**FINAL PROOF SURVEY**

Application No G-10071 Permit No G-9124

**TERRY L NOFZIGER**

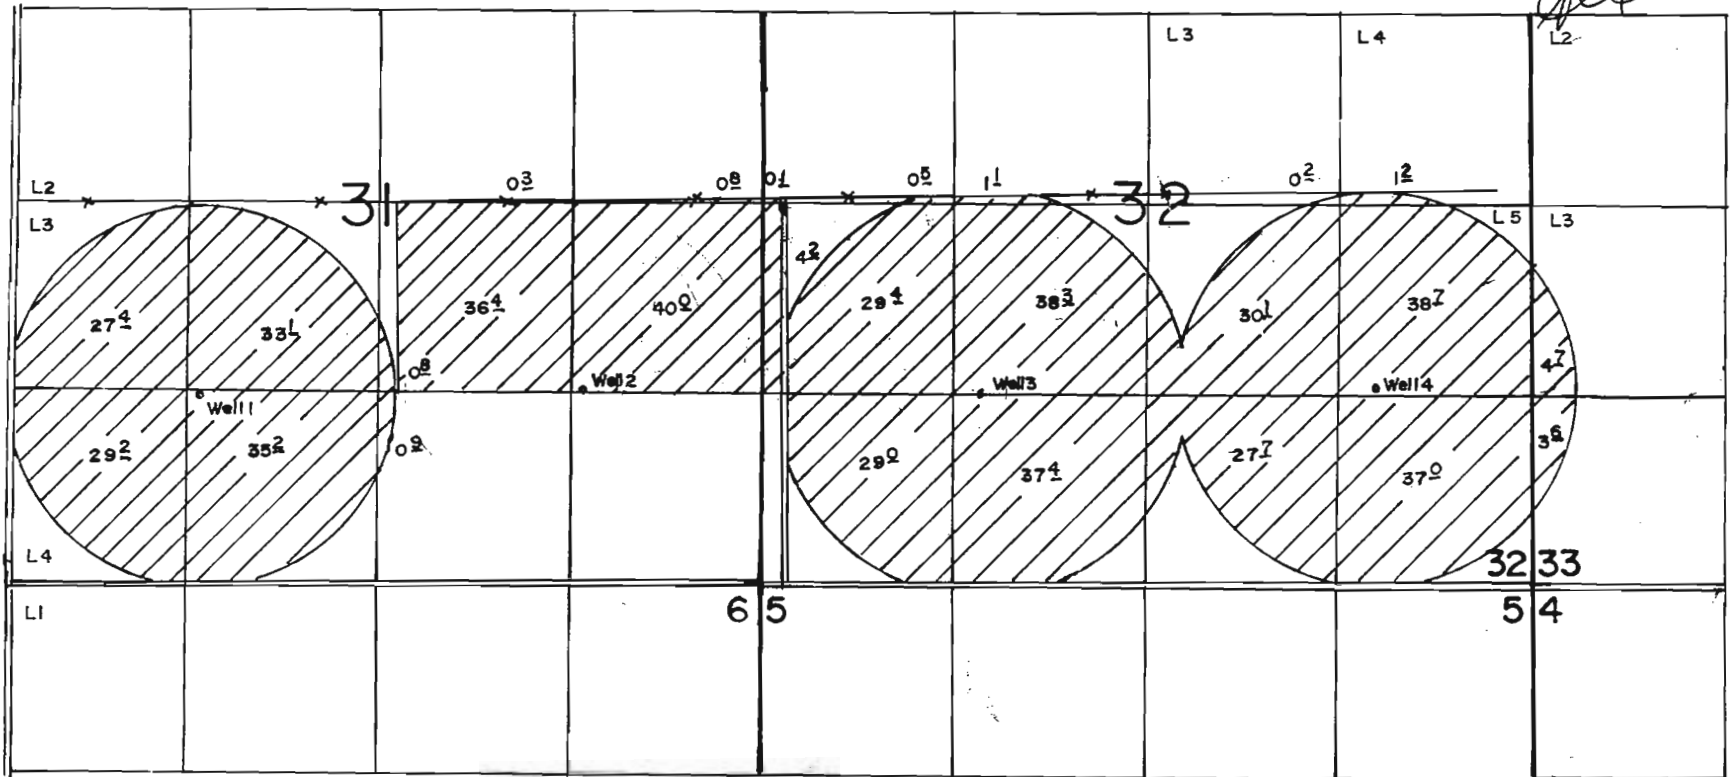
This map is in error.  
 the section/quarter-quarter  
 lines are off. all land is  
 located ~~at~~ within the 1/2  
 of sections 31 & 32. OK to  
 correct based upon a request  
 of the landowner per OAR  
 690-15-400 when requested
